## Replacement of the wiring loom

Part Number: 698364, 698330, 698281

For vehicle: Renault Applications

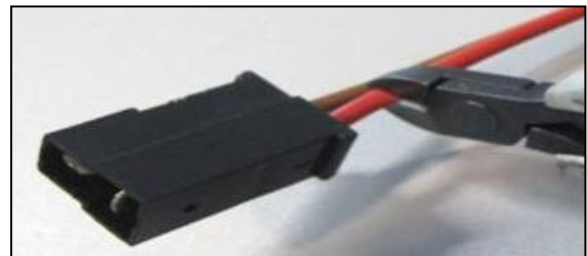
The Valeo Service Technical department have received several calls stating that an additional loom has been supplied with the blower motor but customers are unsure if it is required. Blower motors 698364, 698330 and 698281 have been modified and the original connector must be removed and replaced by the connector provided within the box.

*Old connector*

*New connector*

Remove the old connector by cutting it, make sure beforehand that there is no deterioration on the cable. Strip the cables exposing several centimetres of copper wiring.

Crimp the new connector cables on the existing cables. Add a trunking to protect the cables. It should be remembered that a bad connection, can generate a significant increase of temperature with a risk of fire starting.
